ISSUE DATE: 8/17/09 **PERMIT - Repair** P 531096

**ON-SITE SEWAGE DISPOSAL SYSTEM
HOWARD COUNTY HEALTH DEPARTMENT
BUREAU OF ENVIRONMENTAL HEALTH**

ADDRESS: 16332 Carrs Mill Road PROPERTY OWNER: Frank Castella

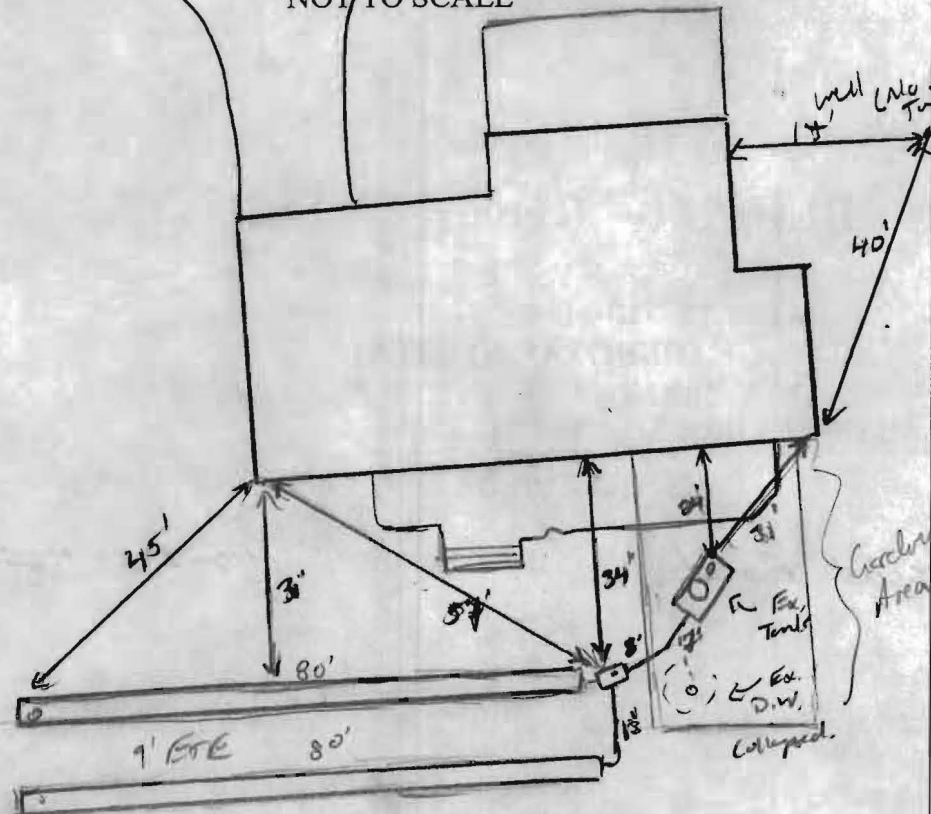
TRENCHES:	Trenches to be 3 feet wide. Inlet 3-4 feet below original grade. Bottom maximum depth 6-6.5 feet below grade. Effective area begins at 5 feet below original grade. Approx. 3 feet of stone below distribution pipe.
LOCATION:	A Layout inspection is required for correct placement and verification of trench locations. 2x80' trenches will be installed w\ observation pipes at the ends.
NOTES:	Trenches will be maintaining 3' of stone below the pipe laterals throughout. Top trench invert may be deeper than 3' to make fall from ex. septic tank. Bottom trench inlet invert will be shallower. Manhole access needs to be installed on the tank. Pump and collapse ex. dry well.

8/25/09 Pre-construction meeting w/ Fogler. Ex. Tank dug up. May not be able to maintain 3' Fall. Keep 4' inlet or close to it as possible. Run 2x80' trenches as specified on plan. Call for resp. (19)

8/26/09 Contractor held .25% fall from tank to Dbox. Could not make 4' inlet @ top trench. 4.5' inlet. Dry well pumped & collapsed. OK to cover (19)
